# Peer Review of Glen Eira's Draft Quality Design Guidelines and Strategic and Urban Renewal Development Plans Analysis

Client: Glen Eira City Council

**AECOM Australia Pty Ltd**

17-Oct-2017

Figure 5 Aerial image of typical site for terrace townhouses – 34-36 Jersey Parade, Carnegie

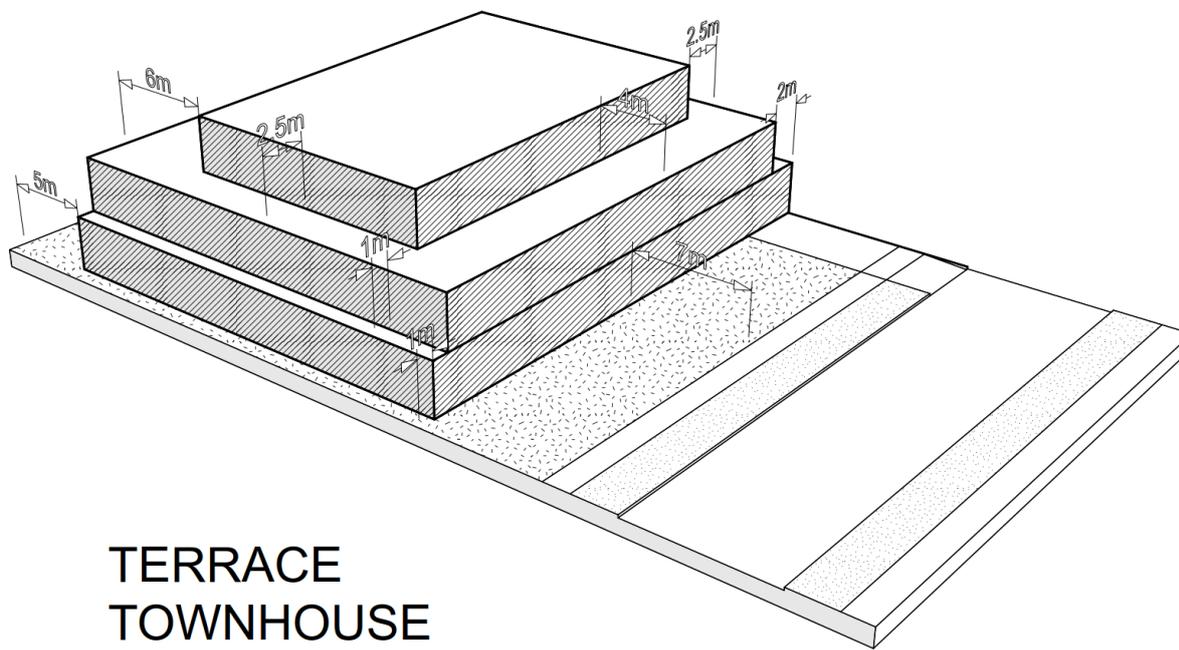
- Undertake further detailed testing of this type to identify optimal and reconciled open space provision, front fence, floor plan layout viability, development yield and economic feasibility.

**Figure 8 Diagram showing setback requirements for terrace townhouse/apartment type**

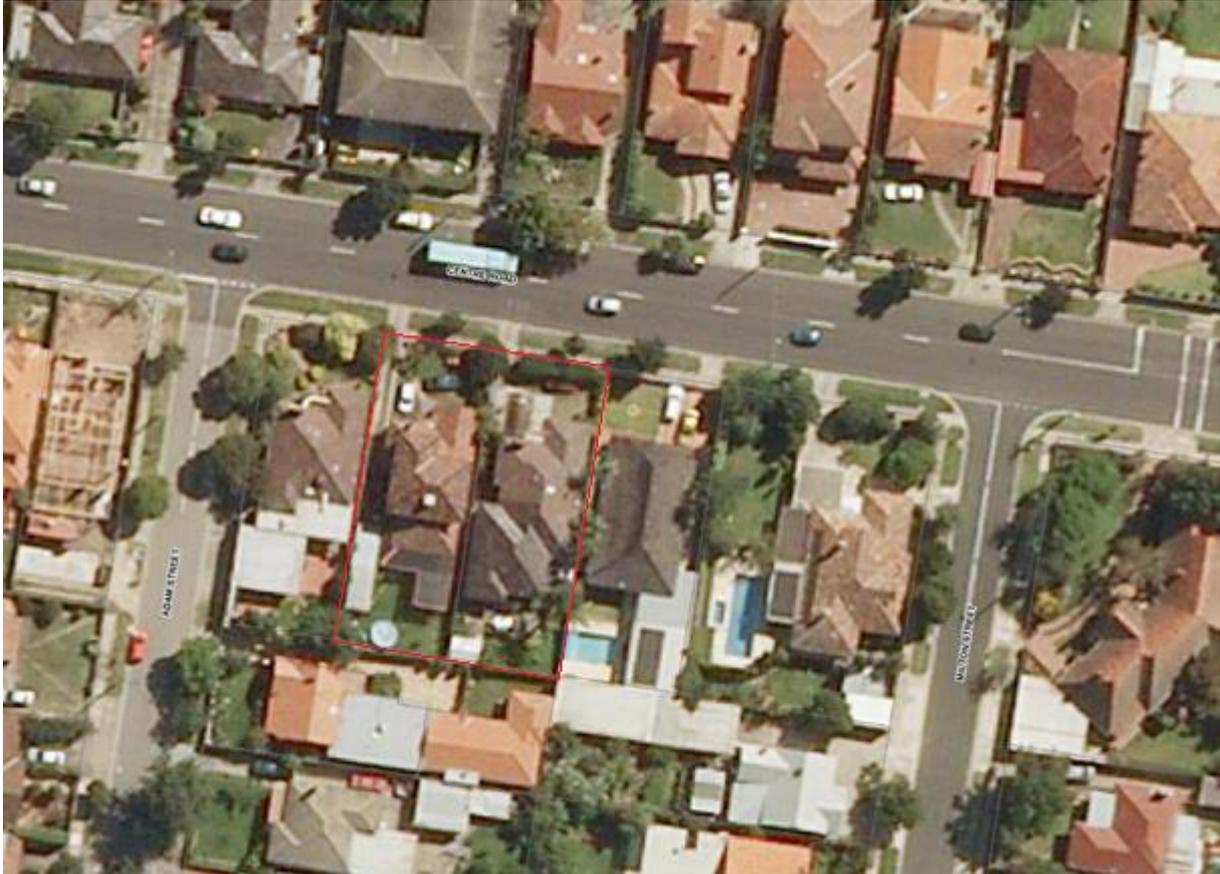
- Undertake further detailed testing of this type to identify optimal and reconciled open space provision, front fence, floor plan layout viability, development yield and economic feasibility.

**Figure 10 Diagram showing setback requirements for garden apartment type**

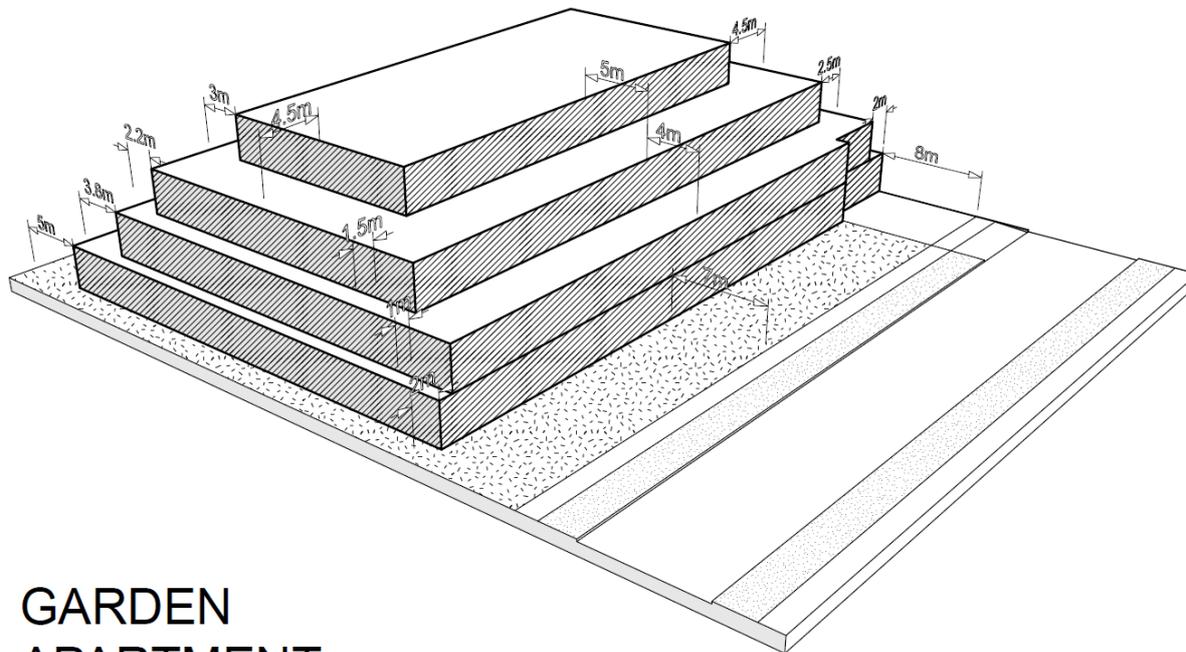
- Reconcile front setback, private open space provision and front fence extents, locations and heights to ensure alignment with State planning policies and optimal development yield.

**Figure 12 Diagram showing setback requirements for heritage/character shop top type**

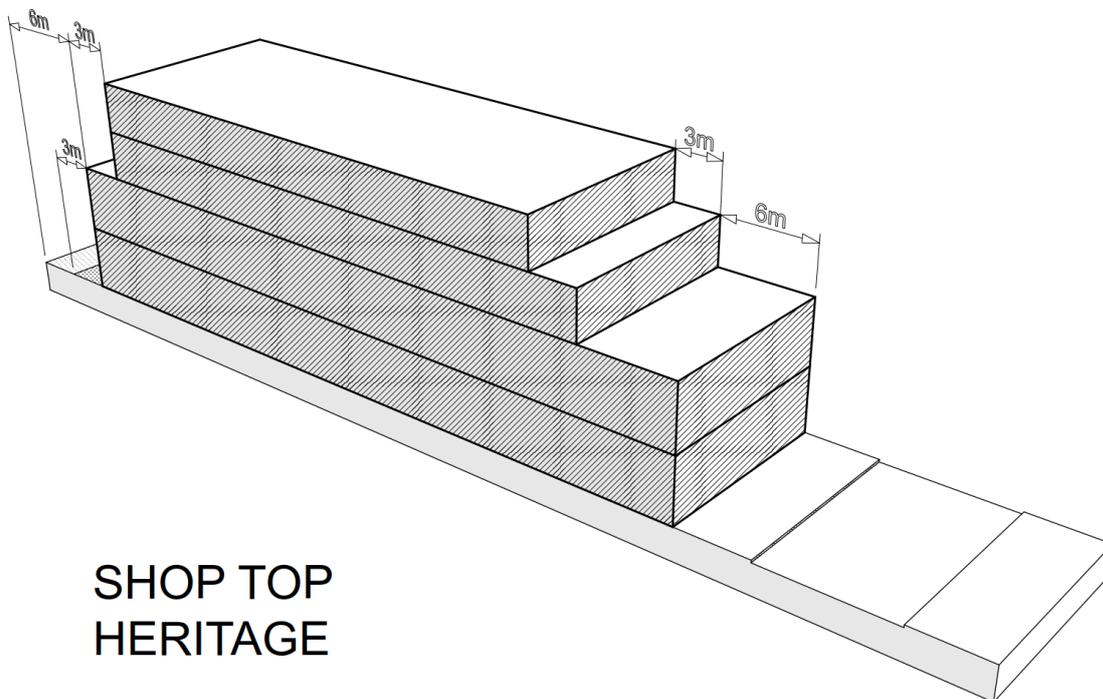
- Provide definition of active laneway locations, and reconcile car parking and vehicle access with laneway frontage objectives.
- Reconcile and optimise the proposed overall height and development potential with the core ground floor retail use of these sites within the retail core of activity centres, and overshadowing of key retail streets.

**Figure 14 Diagram showing setback requirements for shop top type**

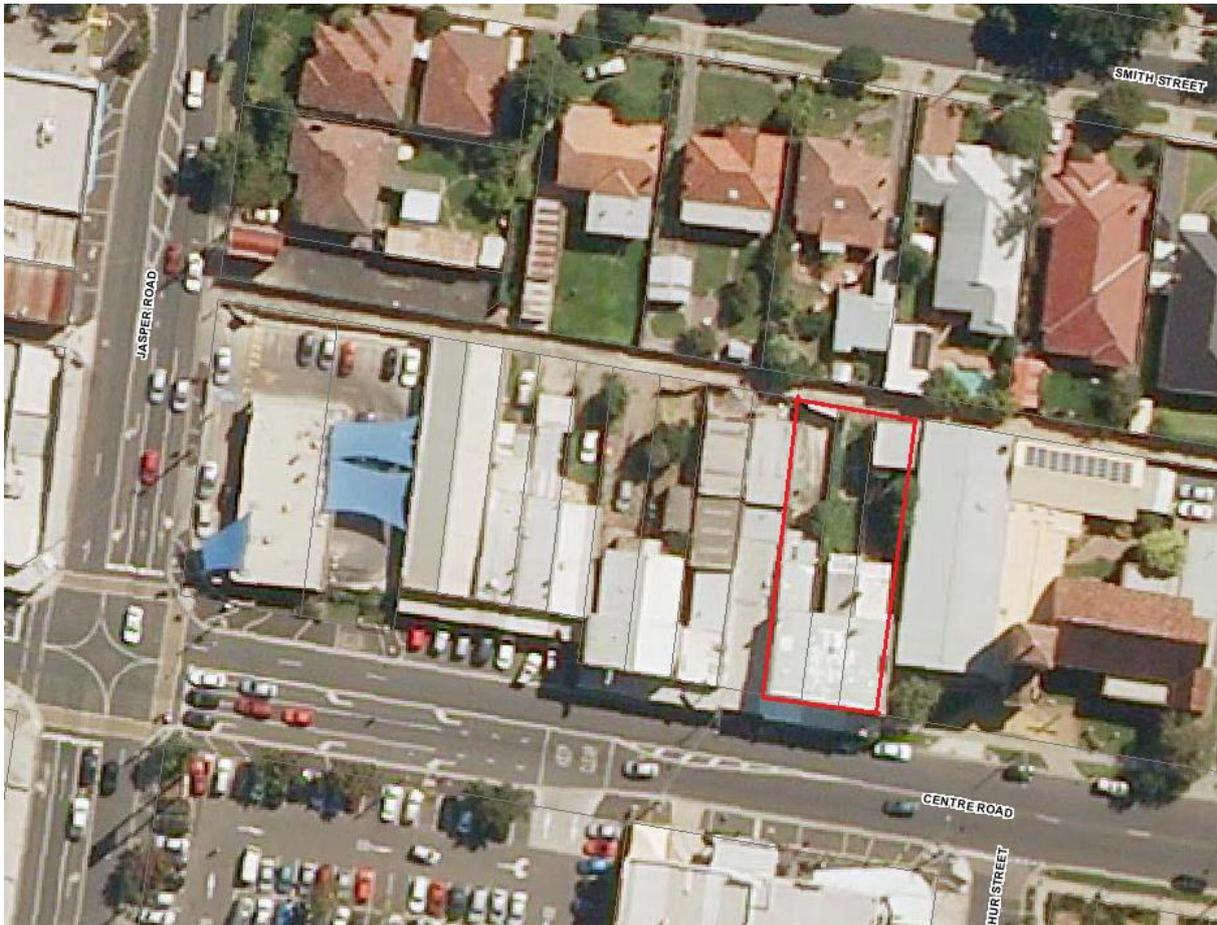
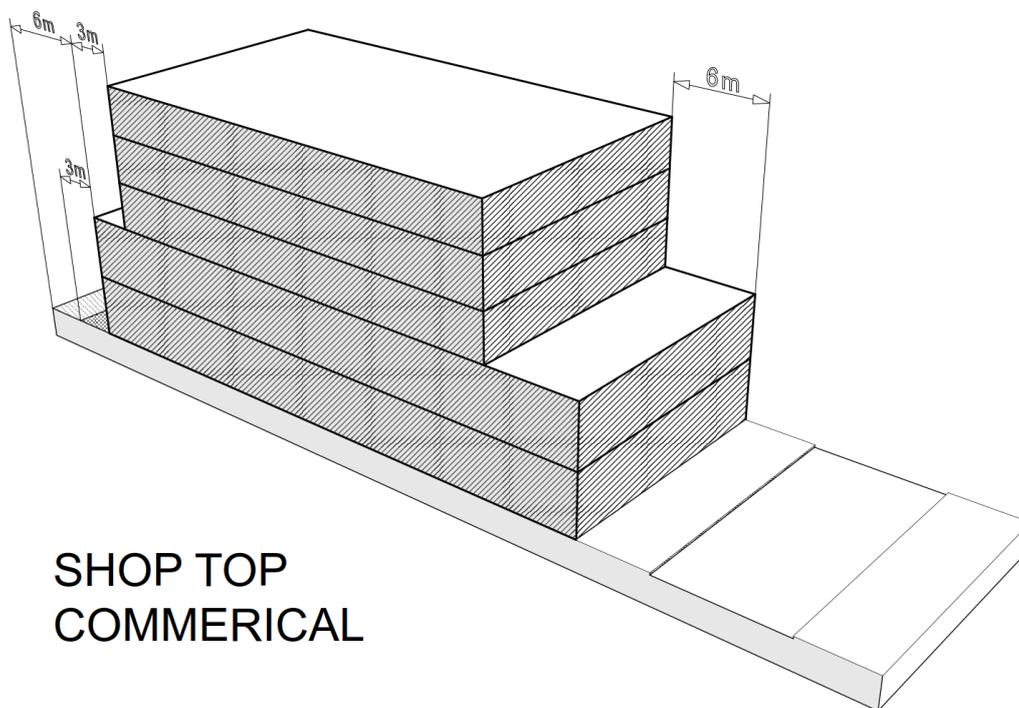
- Provide definition of active laneway locations, and reconcile car parking and vehicle access with laneway frontage objectives.
- Reconcile and optimise the proposed overall height and development potential with the core ground floor retail use of these sites within the retail core of activity centres, and overshadowing of key retail streets.

**Figure 16 Diagram showing setback requirements for strategic site type**

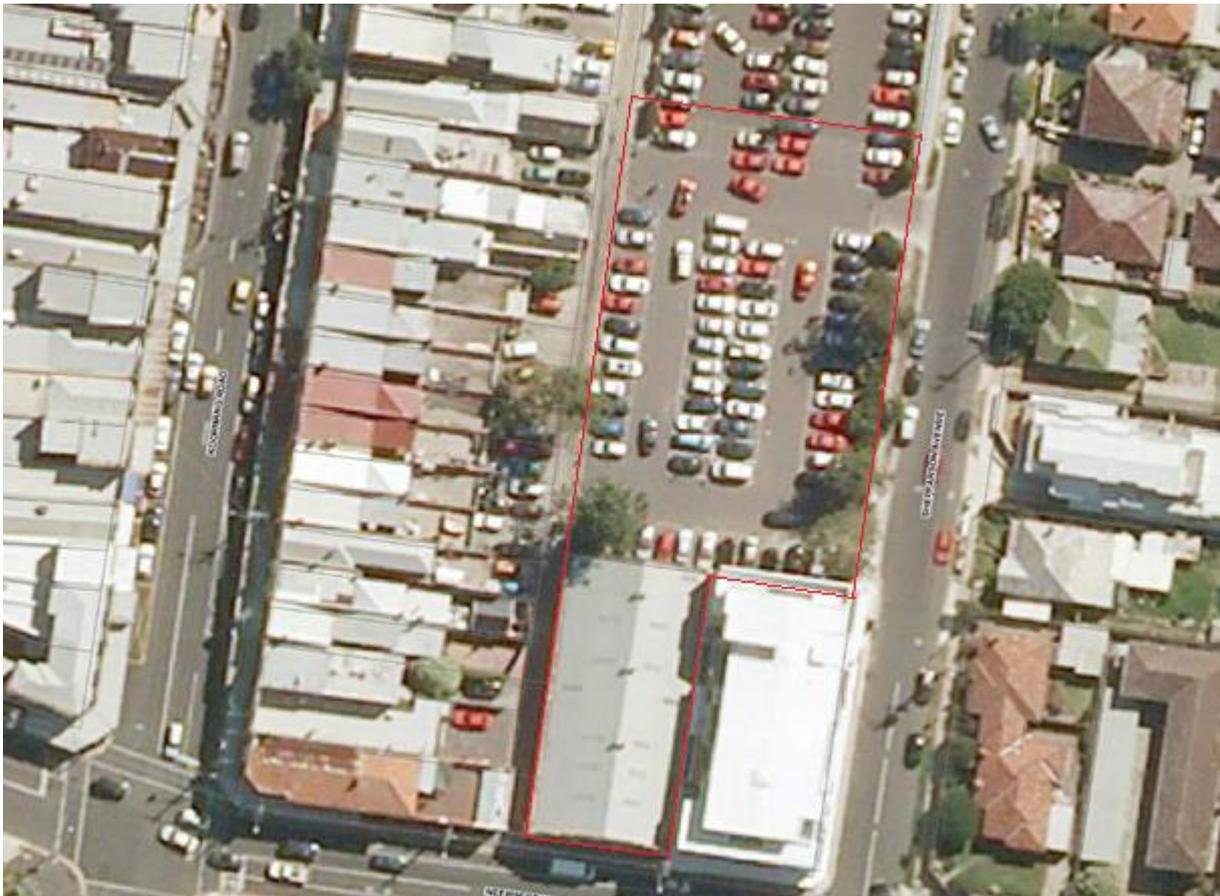
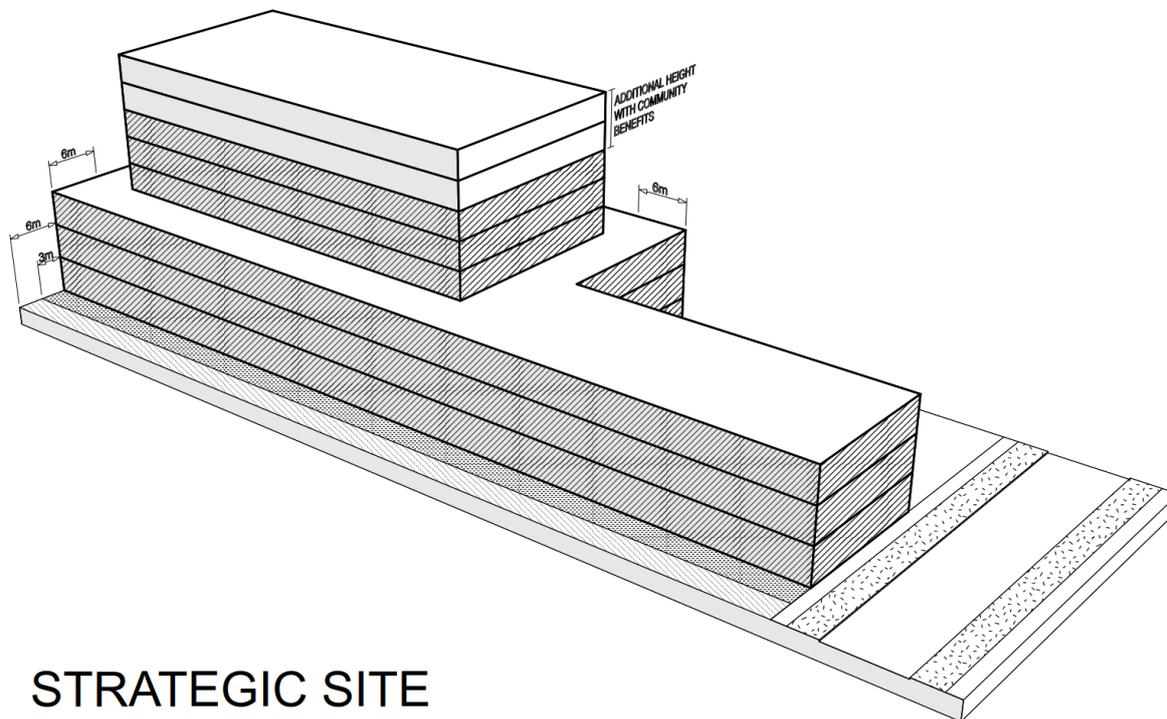
- The cost of replacing the existing 123 Council car parking spaces (all space south of the Council facility at 7 Shepparson Street) would add a further \$6 million to the cost of the development (calculated at \$50,000 per space in a basement) which would further drive down the development profit margin potential and residual land value for the site significantly below the expected purchase cost.

- Provide strong definition, built-in requirements or contractual obligations through sales agreements on the delivery of significant non-residential uses on these sites.
- Provide definition of active laneway locations, and reconcile active laneway frontage objectives with vehicle and loading access needs along laneways.
- Provide definition of community benefits that will be considered as part of the additional height development opportunity and that are appropriate for strategic sites.
- Provide minimum site area requirements that distinguish strategic sites from shop top type development to better clarify and delineate the differences in yield and development potential.

**Figure 18 Diagram showing setback requirements for (typical) urban renewal type buildings**

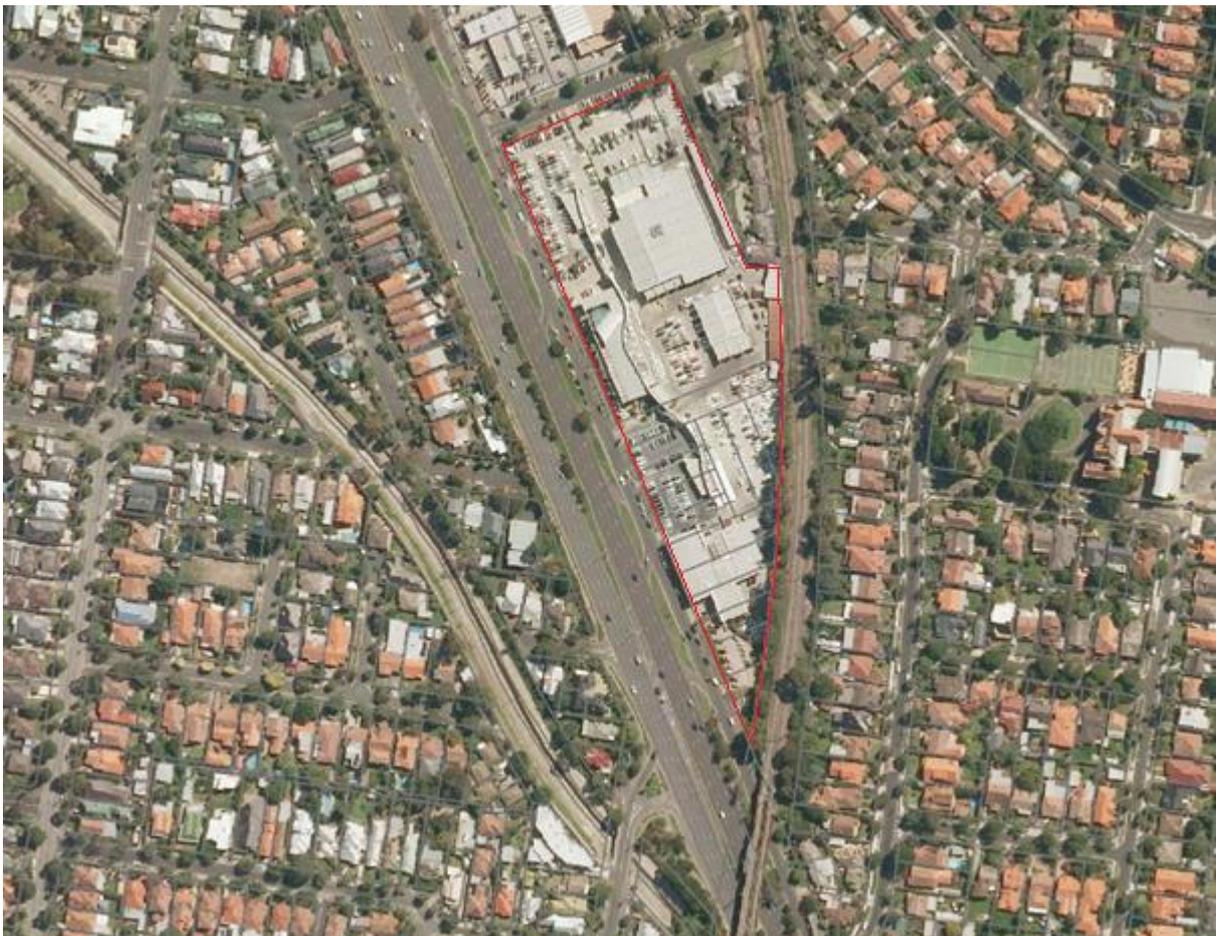
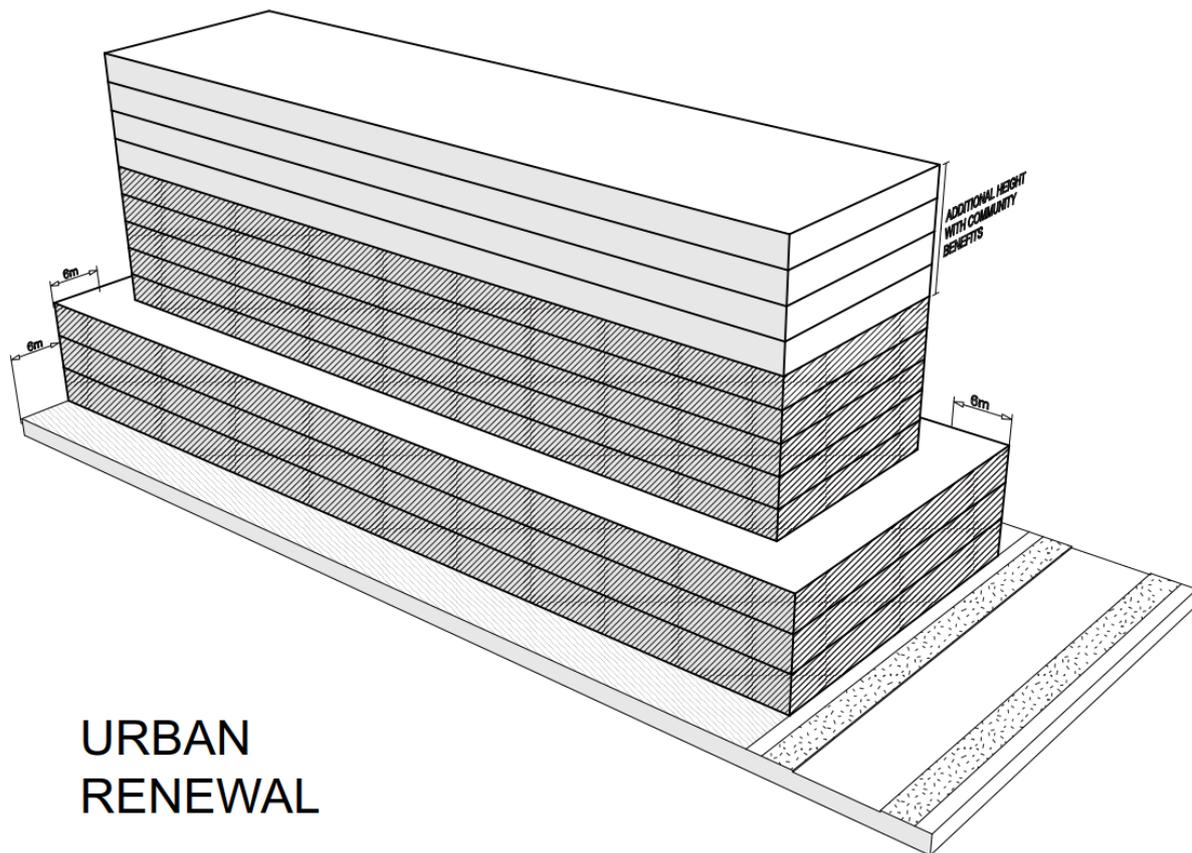
- Provide strong, built-in design and/or land use requirements to ensure the delivery of significant active, commercial uses that accommodate a range of employment and commercial opportunities.

- Provide definition of active laneway locations, and reconcile active laneway frontage objectives with vehicle and loading access needs along laneways.

- Provide greater guidance to acceptable maximum development heights adjacent to residential areas and reconcile this with additional development height potential with community benefits.
